LHCC Questions & Comments on SND Lol (LHCC-I-037), 27 October 2020

Answers by the SND Collaboration, 13th November 2020

LHCC referees:

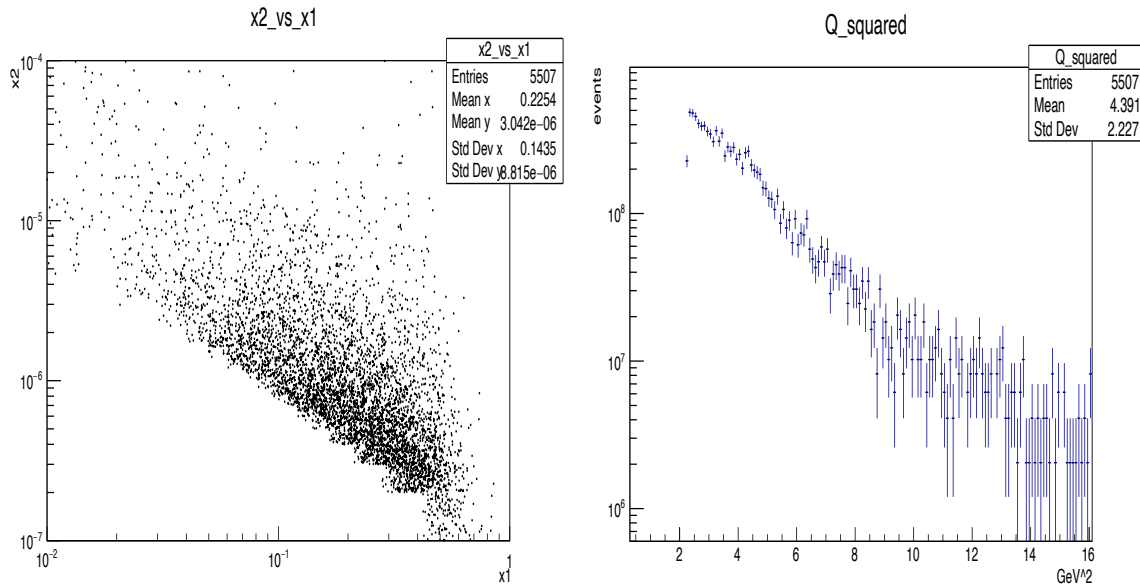
1. Please clarify the primary goals for the neutrino programme. If the goal is to measure heavy quark production in the forward region based on a certain number of observed neutrino events, then this would need to assume a neutrino interaction cross-section. If the goal is to measure the neutrino cross-sections, then this would rely on a calculation of the flux (with associated QCD production cross-section uncertainties etc.). Explain how you propose (with the use of flavour ratios etc.) to disentangle these different measurements. Are there detailed studies

which show how such an analysis will be performed, what are the expected uncertainties and how will the constraints (e.g. on sterile neutrinos) improve on current knowledge?

Observed electron and tau neutrinos are expected to come only from heavy quark decays. In particular, electron neutrinos show a relatively large statistics. The neutrino cross-section has been measured at energies up to 350 GeV for muon neutrinos and it agrees with the standard model with an accuracy of a few percent. One can assume that the electron neutrino cross-section agrees with the standard model too since it would be difficult to argue differently for the first lepton generation. In this case we can use the lower energy part of the spectrum to constrain the heavy quark production and thus obtain a prediction that we can apply to the higher energy part in order to derive the νN cross section beyond 350 GeV.

Muon neutrinos also come from pion/kaon decays and this produces a different energy spectrum. The energy measurement can be used to disentangle the two components. The comparison with the electron neutrino yield at lower energies (below 350 GeV) can be used to derive the pion/kaon contribution in the region where the cross-section is well known.

From the ratio between electron and tau neutrino events, one can derive the tau neutrino cross-section (i.e. a universality test) with about 30% accuracy.

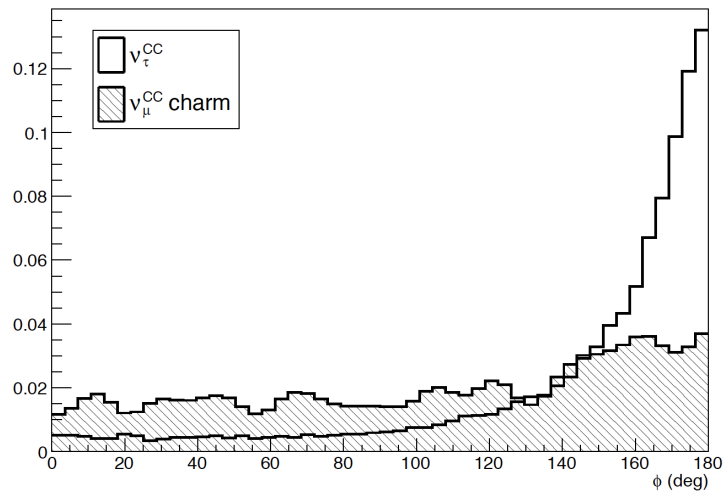
3. The various codes available to model pp interactions in the forward region show important quantitative differences. This is particularly true of the charm production processes, which for SND are a dominant source of e and tau neutrinos. For example, we are aware of warnings from the authors of DPMJET (used as default by SND), that its charm-production predictions have not been validated and are likely to significantly overestimate production rates. Aside from affecting the precision in the extraction of the absolute neutrino flux and thus cross sections etc, this could also bias the overall estimates of the expected statistics. This is a particular concern in the case of the tau neutrinos, where Table 2 predicts at most a score of events. A complete comparison of available event simulation codes, and their impact on the SND measurements, must be documented.

In the paper N. Beni et al., "Further studies on the physics potential of an experiment using LHC neutrinos.", published on J. Phys. G: Nucl. Part. Phys. **47** (2020) 125004, <https://iopscience.iop.org/article/10.1088/1361-6471/aba7ad/pdf>, the neutrino energy spectra and eta distributions were investigated in the region relevant for SND.

The authors used PYTHIA (8.226, with Monash 2013 tune, for b and c quark production and decays) and DPMJET (minimum bias + charm production). DPMJET was embedded in the FLUKA package of CERN EN-STI (F.Cerutti, M.Sabaté-Gilarte), with detailed simulation of the charged particle propagation through the LHC beam line elements.

For the SND rapidity range, it is shown that:

-- electron neutrinos (essential for our measurement strategy) come from charm decays (plots at bottom of fig. 6 and 7)

-- the flux expectations of PYTHIA and DPMJET are in good agreement (fig. 8).
 -- muon neutrinos from charged pion and kaon decays populate lower energies (upper plots in fig.6 and 7).

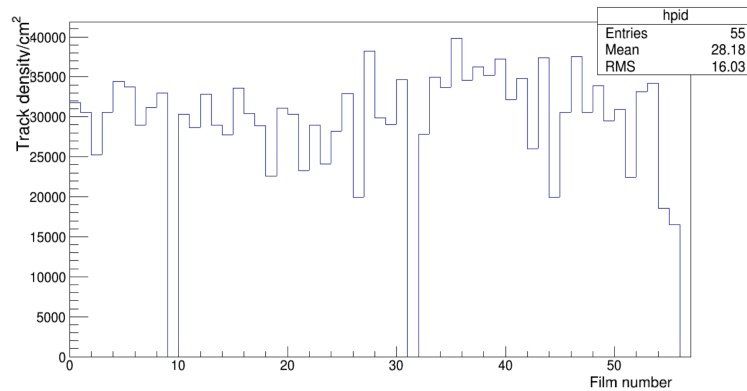
2. It would be expected that the event time for an interaction that results in significant activity in the detector is substantially better than the single particle, single plane time resolution. Since the length of the bunches and the size of the overlap region limits precision of the interaction time to 200 ps , it is not quite obvious why 100 ps or better are needed for individual detector planes. Would a relaxation of the specifications here result in savings in terms of cost, or power budget (and thus cooling needs)?

The collaboration has recently re-discussed the use of the SAMPIC waveform sampling for the muon timing system. The conclusion was that a significant simplification can be achieved by using the SciFi DAQ system, based on the TOFPET2 timing ASIC for the scintillator bars as well (VETO and muon stations). This also leads to a read-out system based on a unique board for all detectors. Event building, timing alignment, synchronisation will be simplified. In this scheme power consumption for the muon timing system is a minor concern. Using the SciFi DAQ boards reduces significantly the cost for the readout electronics.

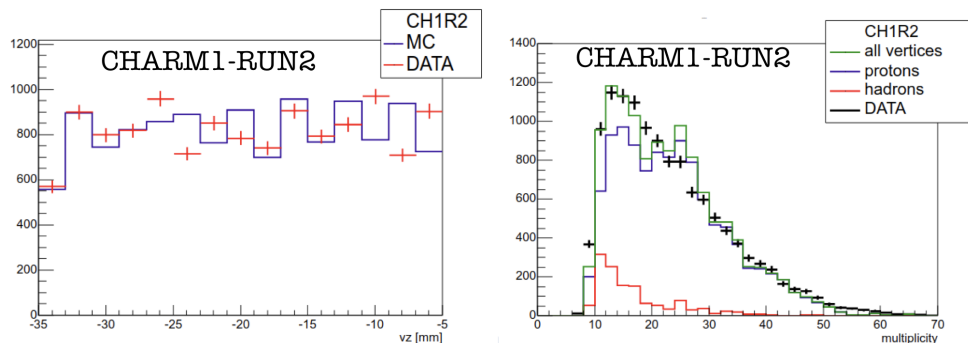
5. Figure 21, there is 30-50% difference between data and MC in the first half of the z distribution. If this is really mis-modelling, what would be the consequences for the SND measurements?

The analysis was recently finalised and a very good agreement was observed between data and simulations. An example from one of the SHiP-charm runs is reported in the picture below, for vertex position along the beam direction and for track multiplicity.
